Service Bulletin

Bulletin No.: 21-NA-276

Subject: Starter Not Cranking Engine, Starter Inoperative, Grinding Noise When Starting

This Service Bulletin replaces PIP5708B. Please discard all versions of PIP5708.

5521948

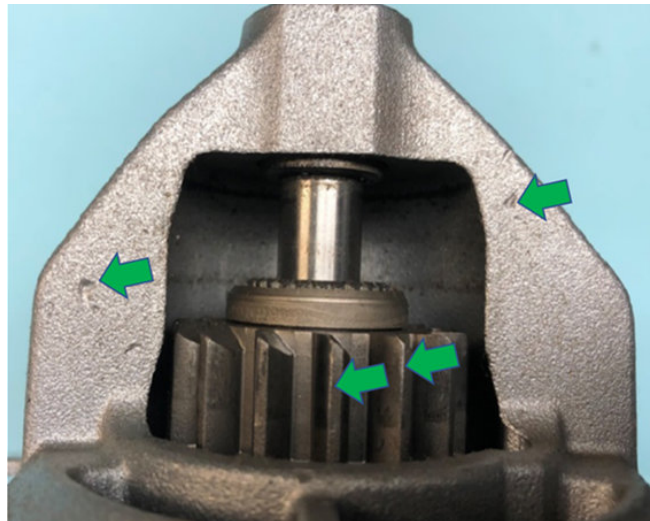
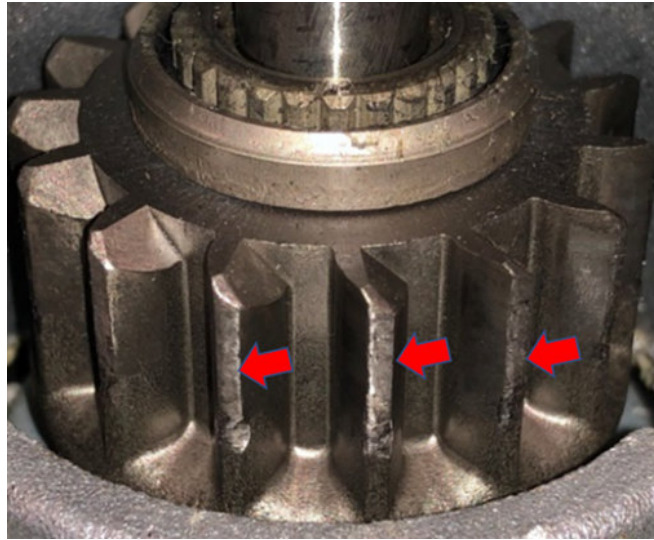
Involved Region or Country	North America, Australia/New Zealand
Condition	Some customers may comment on one or more of the following conditions: <ul style="list-style-type: none"> • Starter spins but it is not cranking over the engine • A grinding noise when starting the engine • Starter inoperative
Cause	This condition may be caused by broken and/or damaged teeth on the flex plate. Note: If the starter does not work, inspect the F5BA (500A) fuse for an open.
Correction	Replace the flex plate and inspect the starter motor drive pinion teeth for noticeable damage. <ul style="list-style-type: none"> ⇒ Remove any broken flex plate teeth or metal debris that may be found on the back of the engine assembly and in the transmission bell housing area. ⇒ If the starter pinion drive teeth or housing only have very small imperfections/pitting, Do Not replace the starter motor assembly, reuse/reinstall it. Refer to the pictures below to determine if the starter assembly can be reused/reinstalled. Examples of starters that can be reused/reinstalled:

5521950

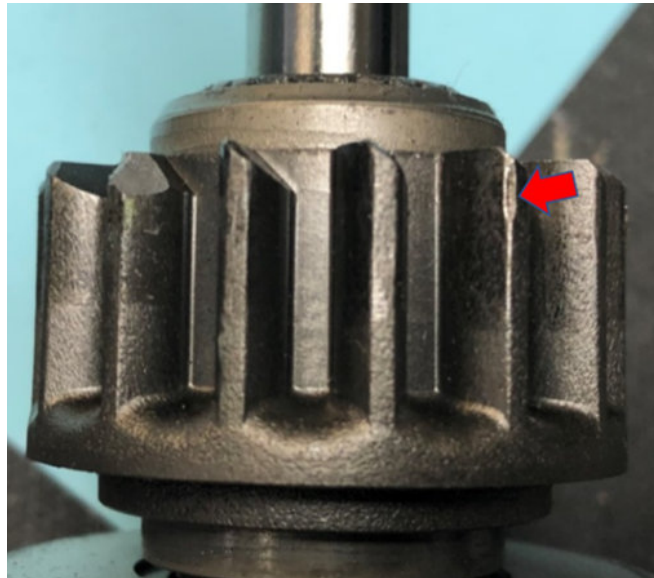
If the starter pinion drive teeth or housing have pieces/chunks missing, replace the starter motor assembly.

Examples below of starters not to reuse/reinstall:
